**ADDENDUM NUMBER ONE:        DATED: April 2, 2020**

This addendum forms a part of the Contract Documents and modifies the original Specifications and Drawings dated March 12, 2020, as noted below. **Acknowledge receipt of this Addendum in the space provided on the Bid Form;** failure to do so may subject bidder to disqualification.

PROJECT:  
**RENOVATIONS, MODIFICATIONS AND ADDITIONS TO HENRY COUNTY SCHOOLS - PERFORMING ARTS CENTER**

RTAC-SC-1 THRU RTAC-SC-3 CONTROL FLOW DIAGRAM

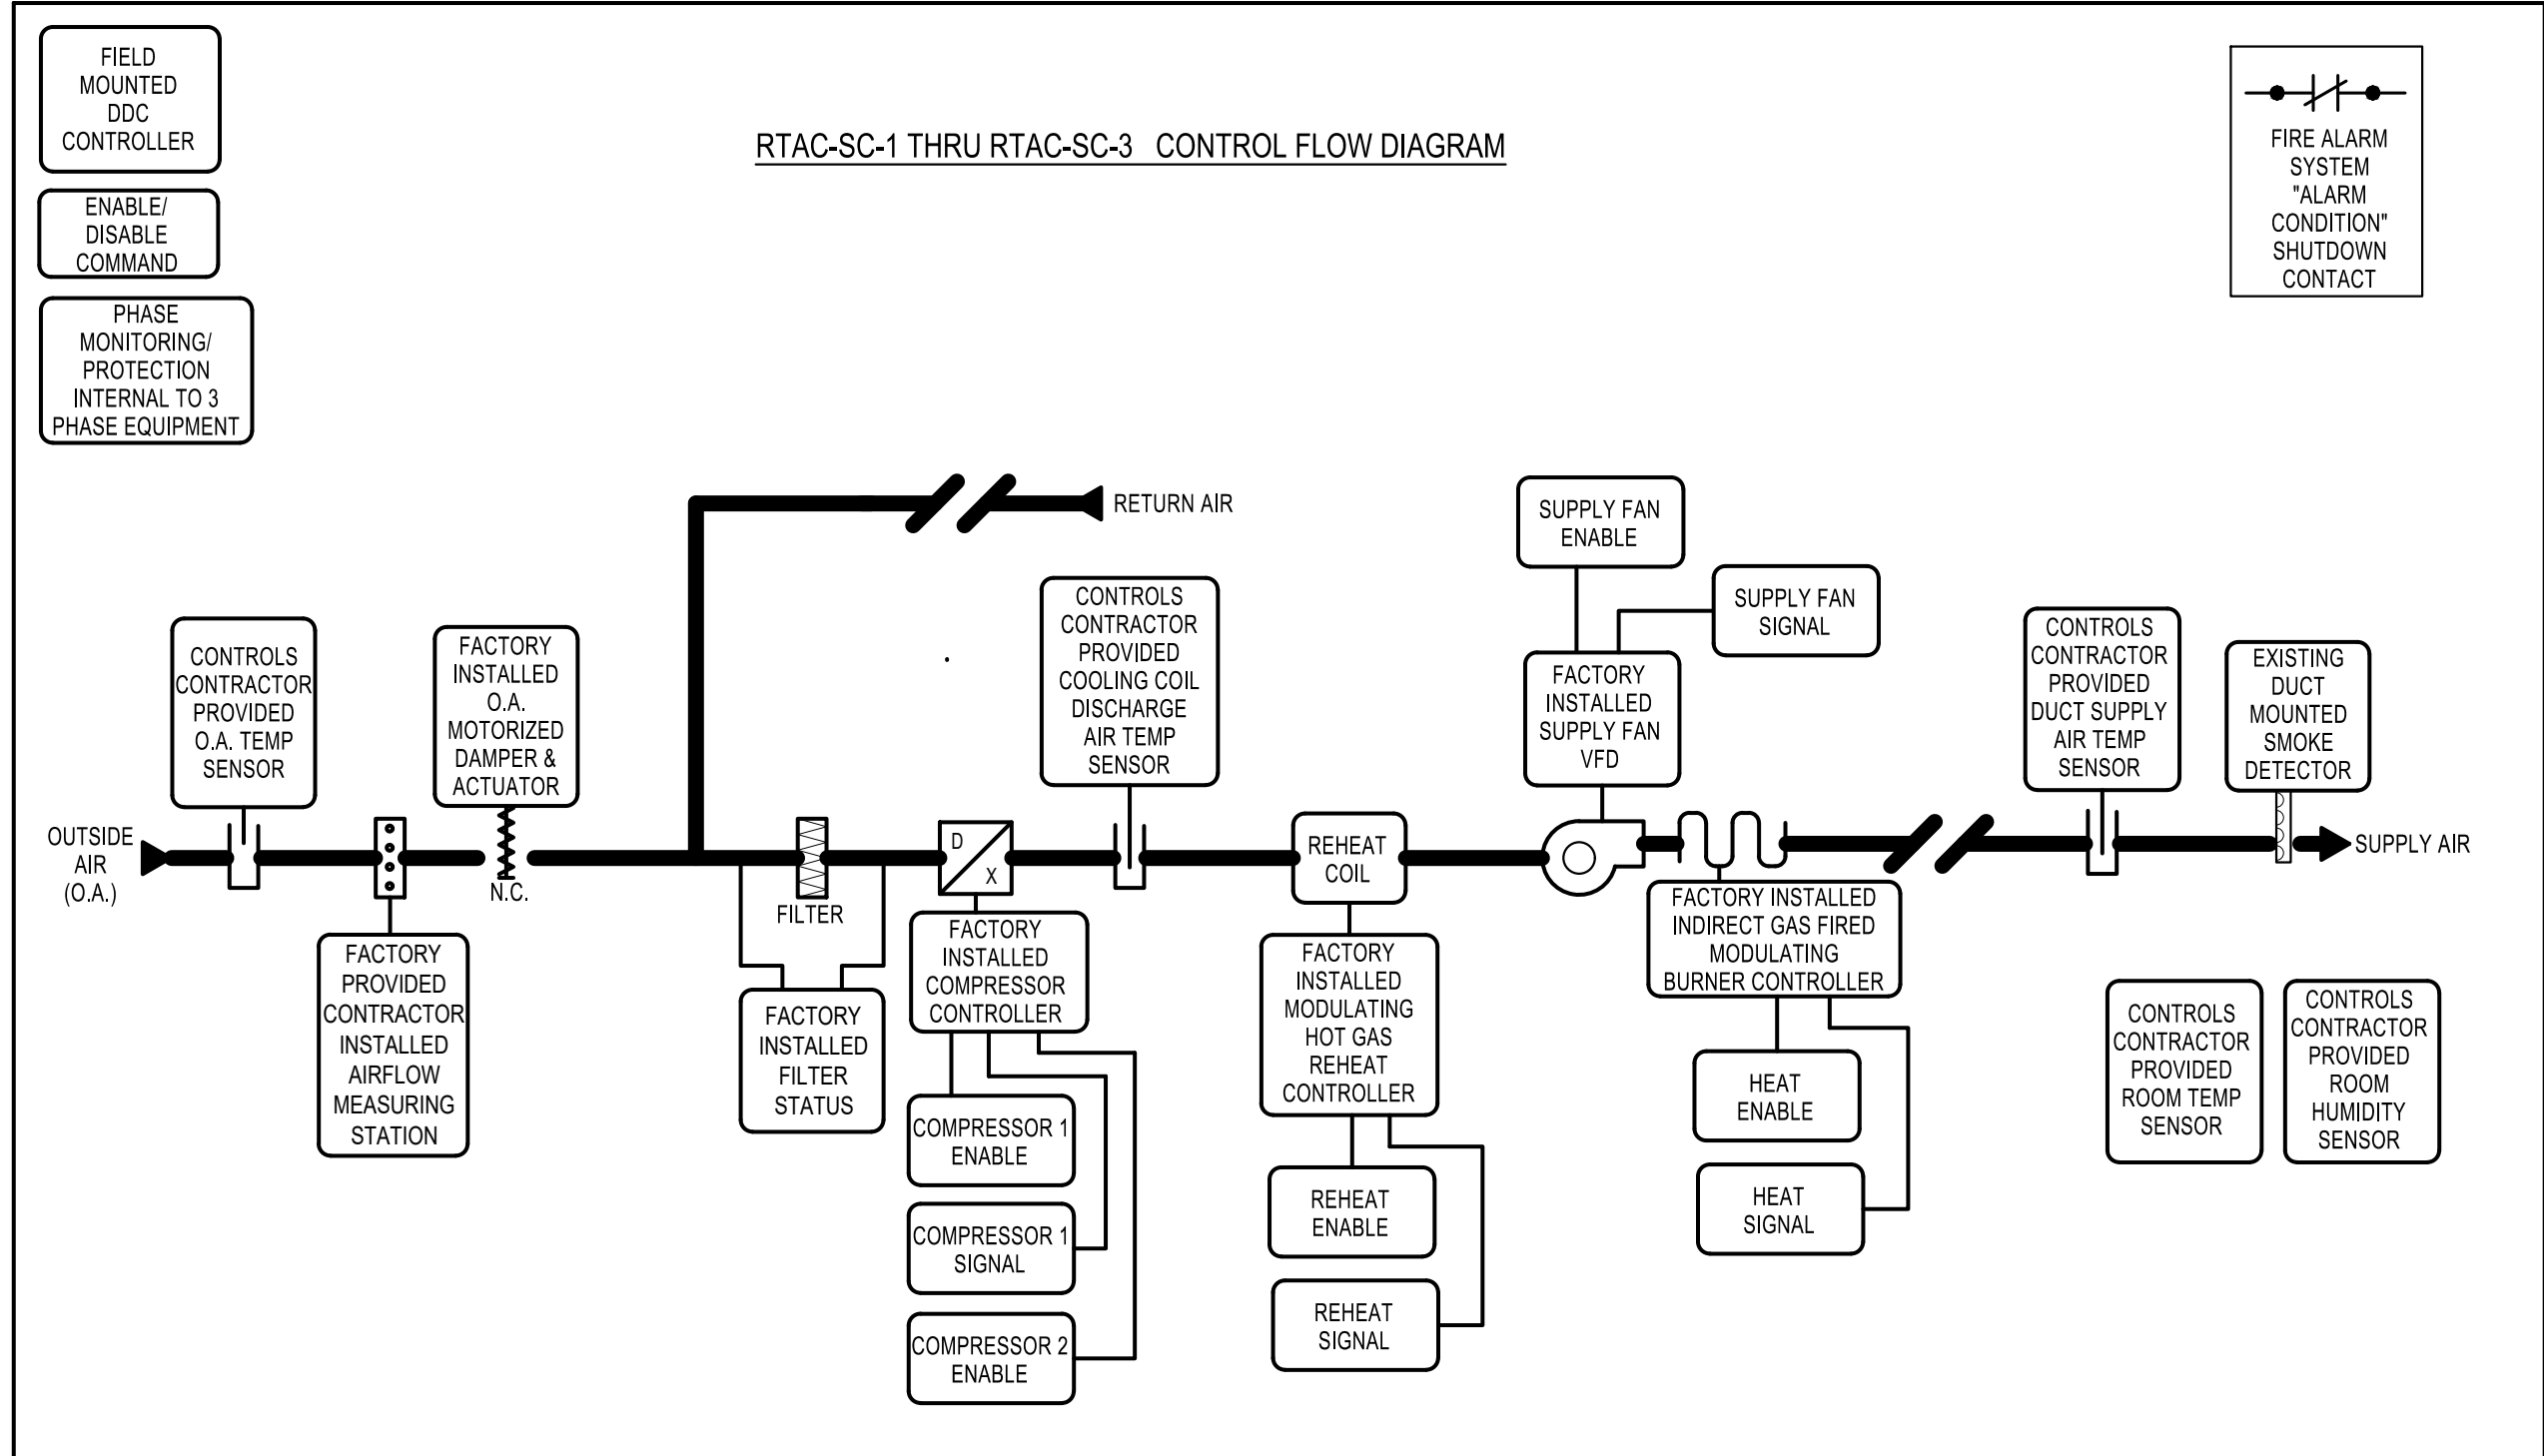
9. Sheet M5.12 - Mechanical Details
  - A. Add “RTAC-SC-1 thru RTAC-SC-3 Control Flow Diagram” as shown on supplemental drawing SD-M5.12, included herein.

SHEET NO.: **E0.01**

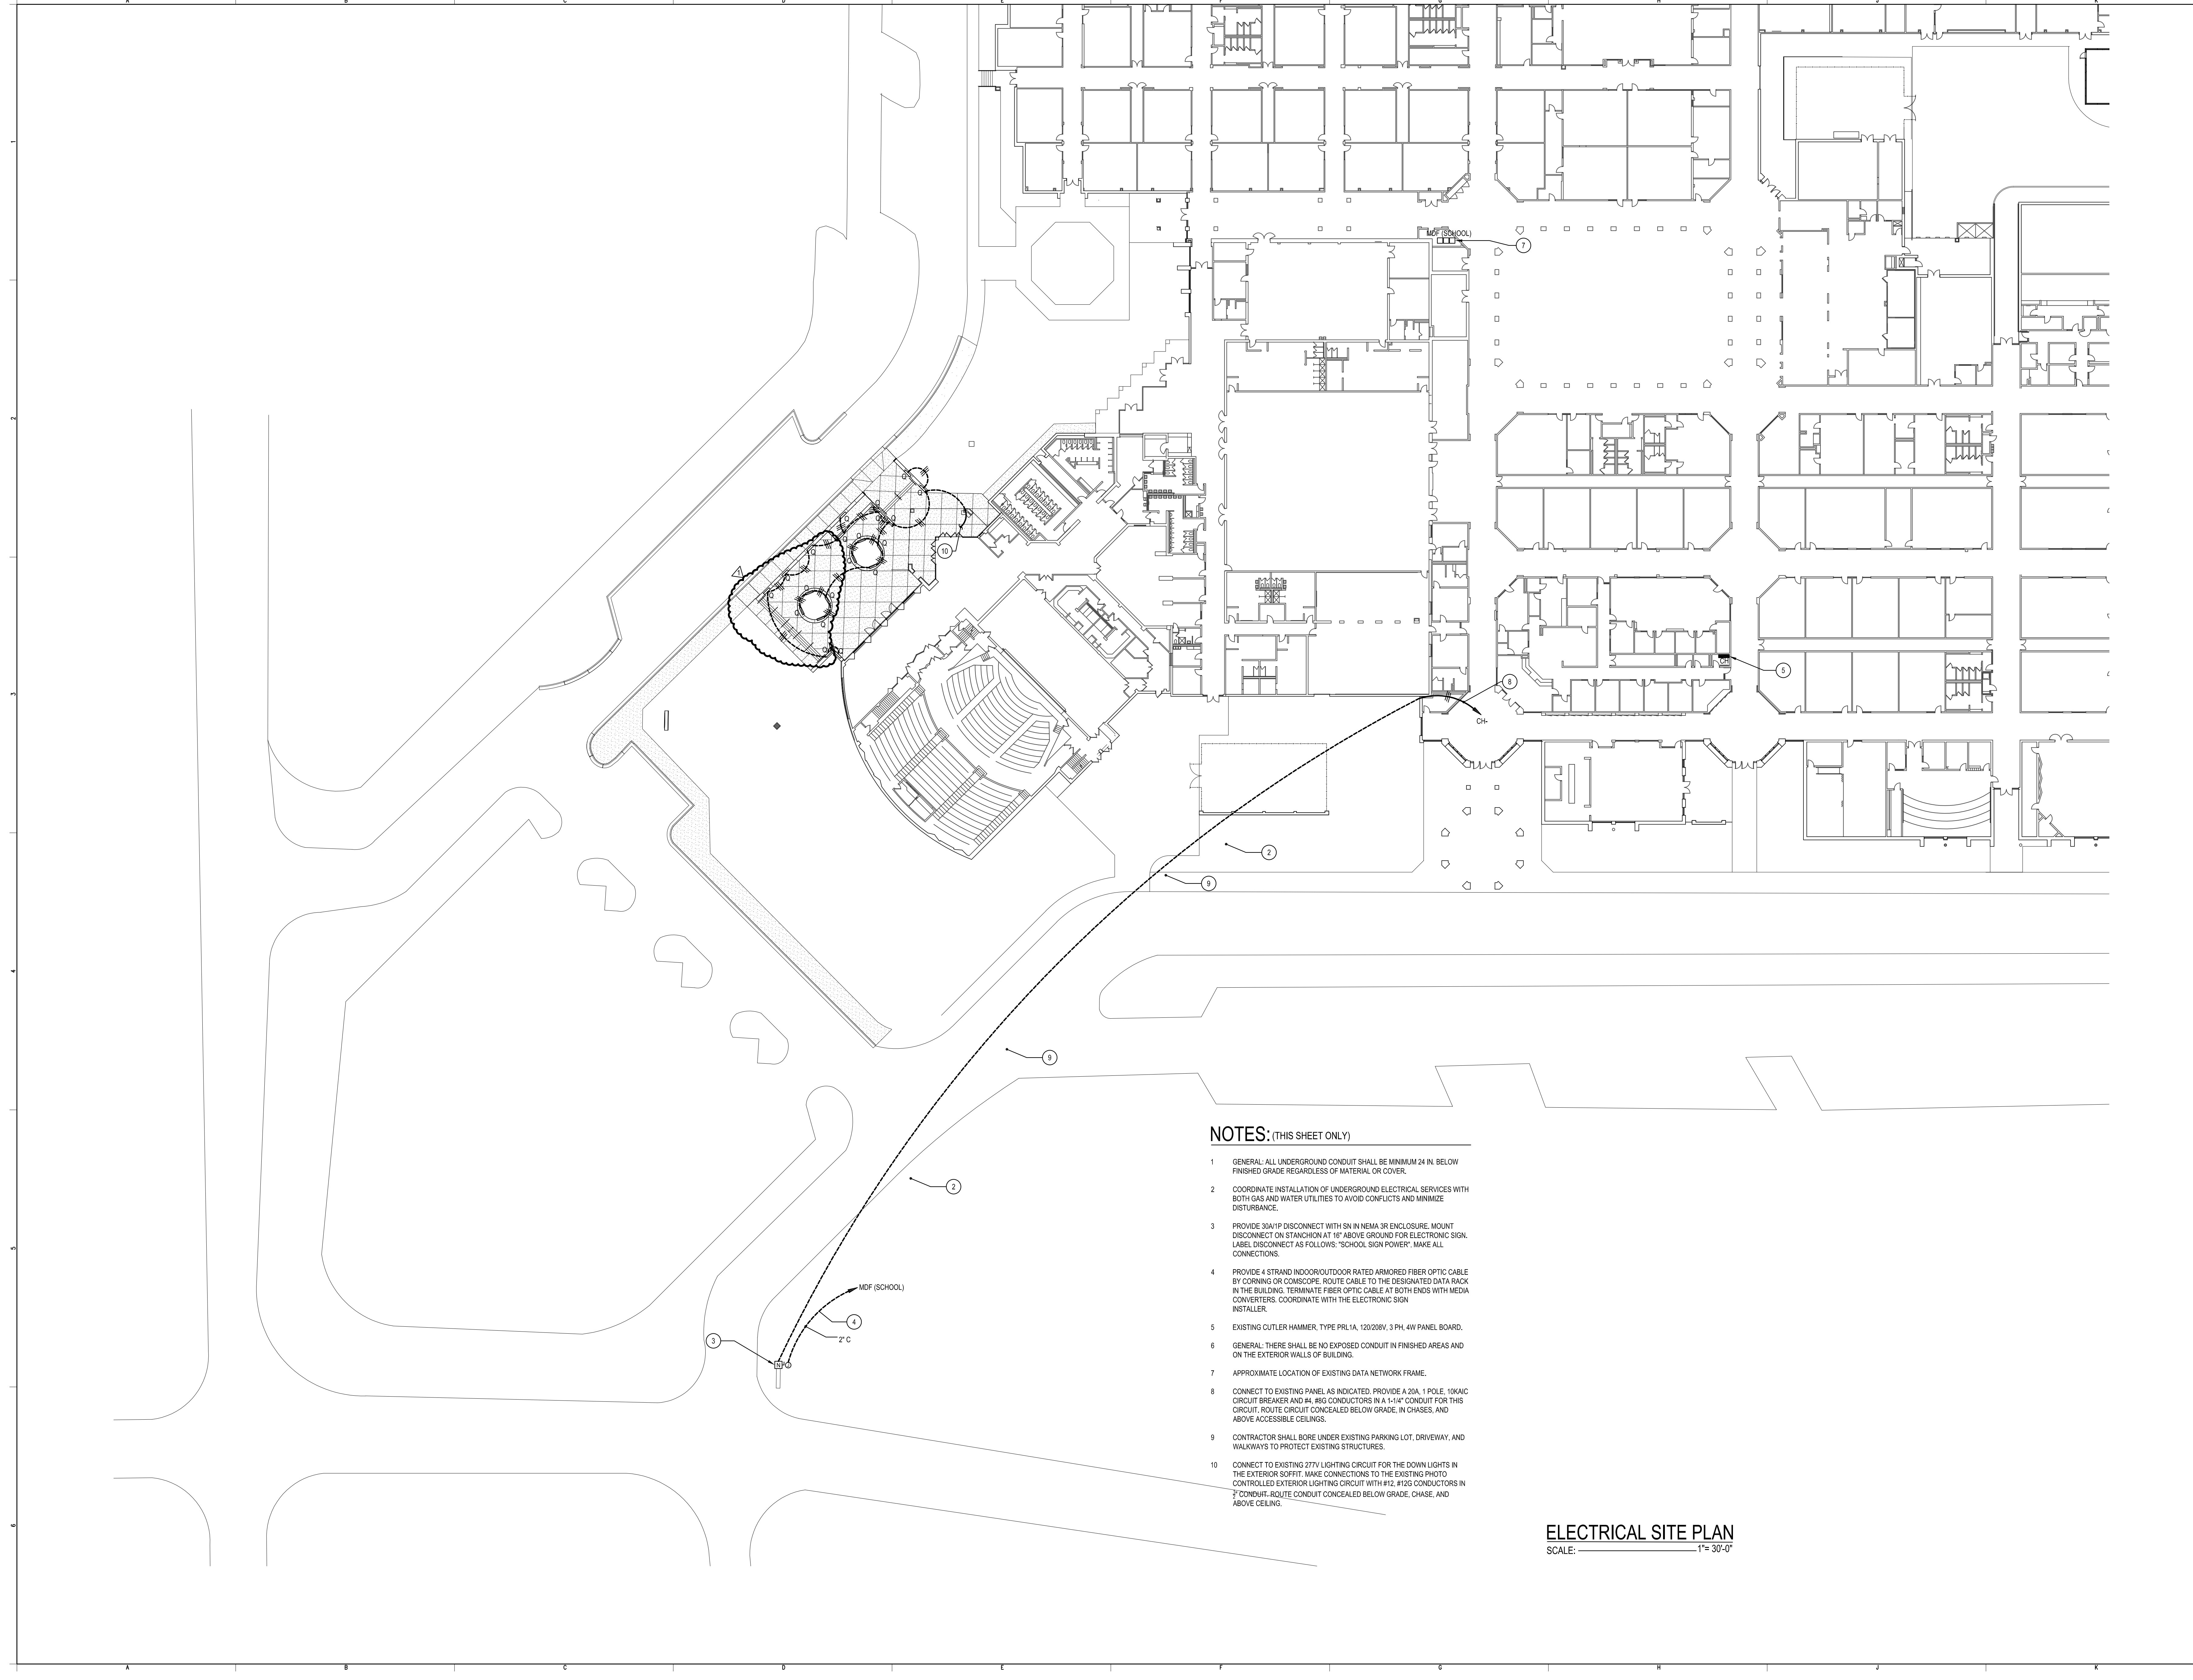
- A. Revise exterior lighting layout in the new Plaza area as shown on the revised sheet E0.01, included herewith.
